RESPONSE TO REQUEST FOR ADDITIONAL INFORMATION

US-APWR Design Certification

Docket No. 52-021

RAI NO.: NO. 1050-7218 REVISION 3
SRP SECTION: 03.07.02 – Seismic System Analysis
APPLICATION SECTION: 3.7.2
DATE OF RAI ISSUE: 08/30/2013

Figure 1 R/B Complex Contact Pressure Contours – Sliding is Allowed, but Separation is Not Allowed at the Foundation Subgrade Interface. Dark Blue Color Indicates the Area of the Interface that is in Tension (about 18% of total basemat surface).

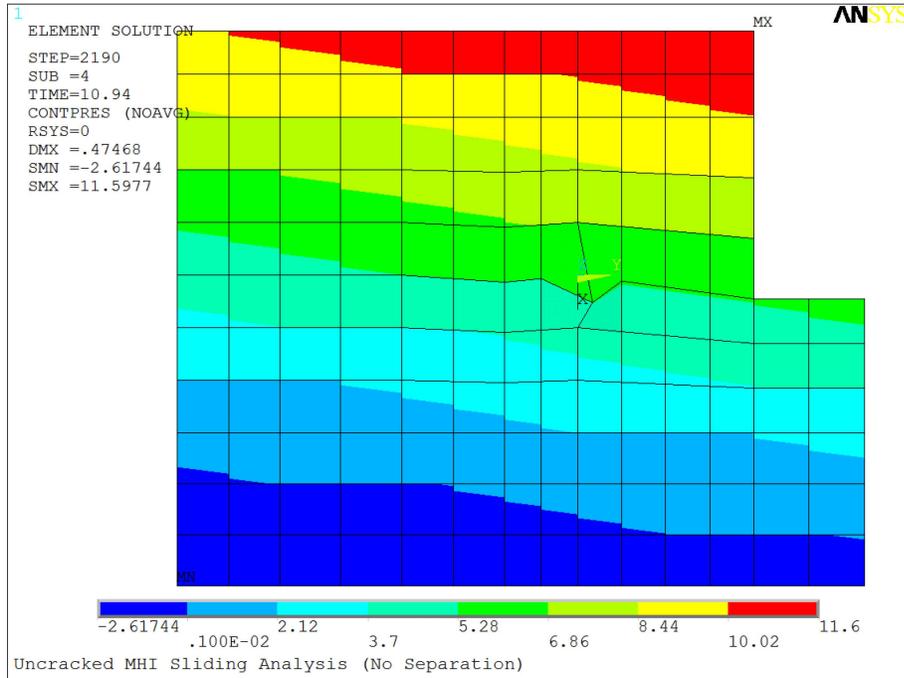
The staff requests the applicant to describe how the potential for uplift of the foundation basemat from the underlying soil/rock was evaluated for the generic cases considered. In addressing this, for each case considered, quantify the minimum area of the basemat that remains under compression at all times during the transient response (considering the simultaneous effect of the three design-basis ground motions and all applicable gravity loads), as a percentage of the total basemat area. In evaluating potential uplift, assess the acceptability of the uplift relative to acceptable engineering practice. An acceptable method for assessing the potential for basemat uplift is described in SRP (Rev 4), Section 3.7.2.

The contact pressure contours calculated at time instant T = 10.9 seconds are presented in Figure 1. The minimum contact area ratio was calculated “using the minimum basemat area that remains in compression with the soil” (Reference 2) and was found to be 82%. This satisfies the minimum 80 percent requirement as indicated in SRP 3.7.2 Acceptance Criteria II.4 Revision 4. It is therefore concluded that the linear SSI analysis methods used for US-APWR standard plant are acceptable.
